The new tools has been released that integrates the new PT-MAP 5.5 sensor (fig. 1).

190000112 - Rev.00 - 11/04/2022

Fig. 1

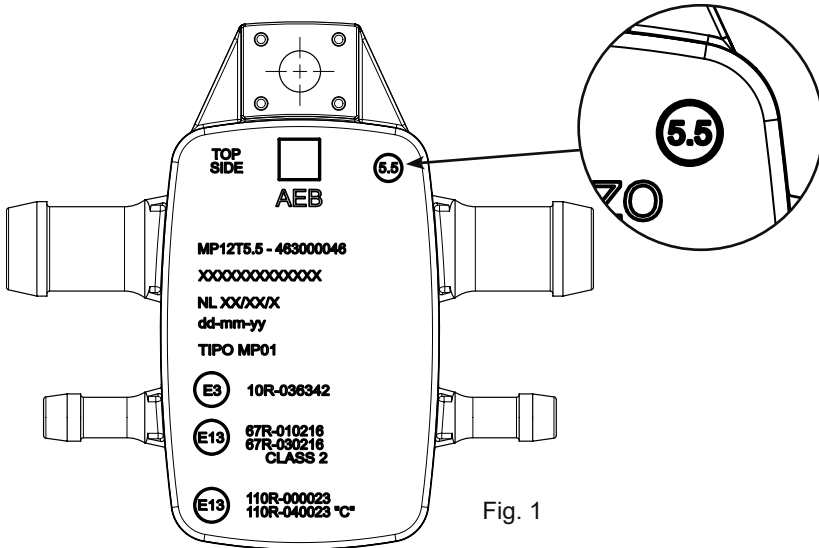
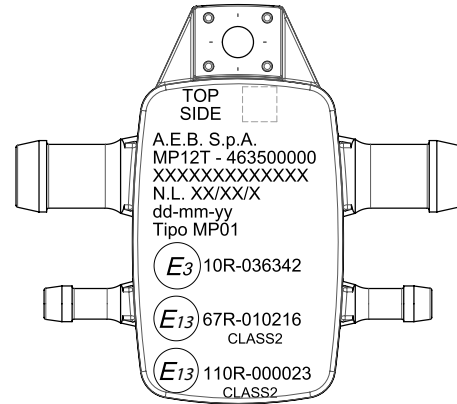
The new PT-MAP 5.5 sensor (that can have the following codes 463000045,463000046,463000051) differs from the old one, by the detail shown below (marking 5.5):

Fig. 3

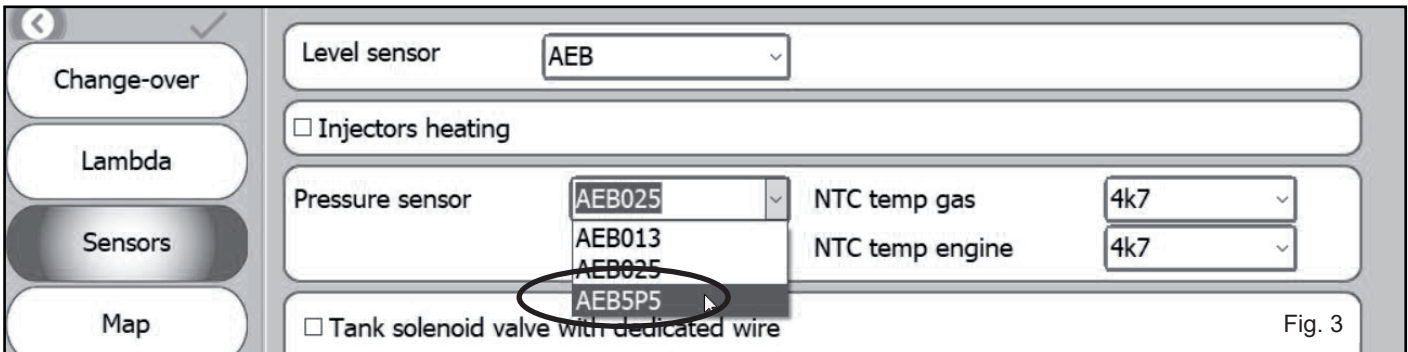
Select the new sensor type AEB5P5 from the selective window menu (Multipoint software version):

**ATTENTION: by selecting the AEB5P5 sensor, the map file will not be changed.**

Fig. 3a

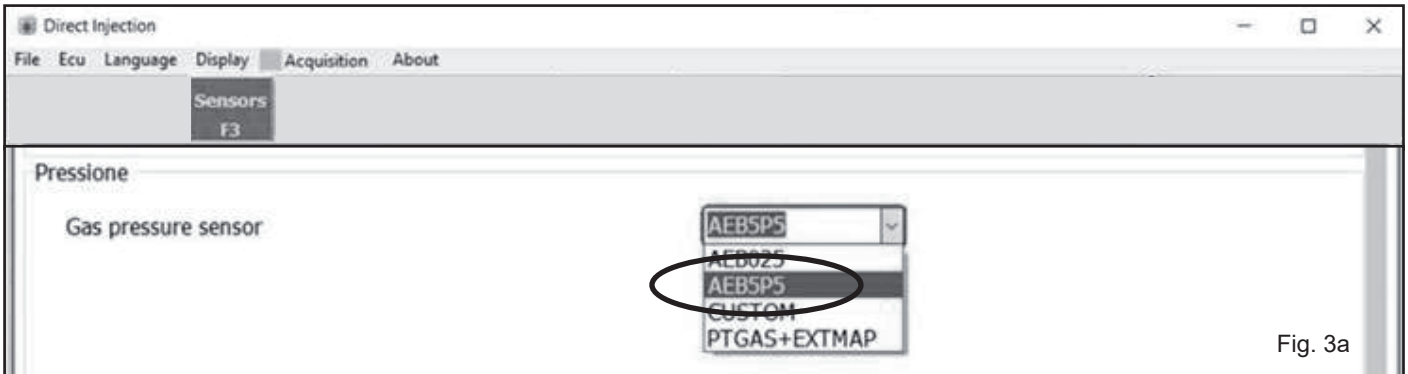
Select the new sensor type AEB5P5 from the selective window menu (Direct Injection software version):
